# SPARK KNOCK UNDER LIGHT LOAD AND ACCELERATION—3.8L, 3.9L, AND 4.2L—SPLIT PORT INTAKE MANIFOLD RUNNER CONTROL (IMRC)

TSB 07-16-17

Figure 1 - Article 07-16-17

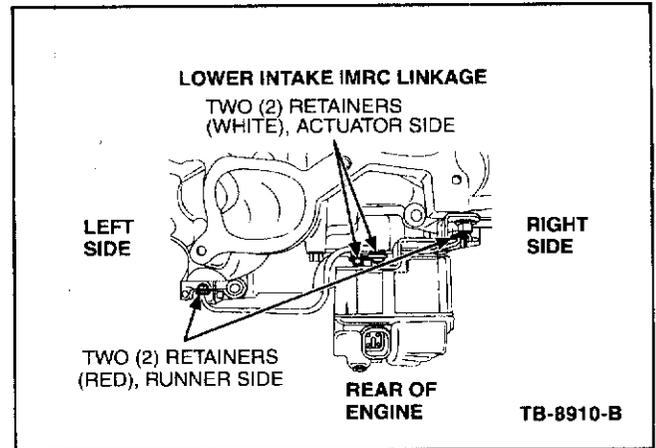
1. Check both right hand and left hand side IMRC rods are properly attached to the actuator motor and intake manifold runner.
2. If the IMRC actuator rods are found to be connected properly, do not continue with this TSB. Refer to Powertrain Control/Emission Diagnosis Manual.
3. If any IMRC actuator rods are disconnected, refer to Workshop Manual (WSM), Section 303-14 for IMRC service.
4. If any IMRC actuator rod linkages are found disconnected, replace all four (4) linkage rod retainers. (Figure1)

PART NUMBER	PART NAME
F5RZ-9F955-AB	Retainer - Actuator Side (2 Required - White Color)
6F2Z-9F955-A	Retainer - Runner Side (2 Required - Red Color)
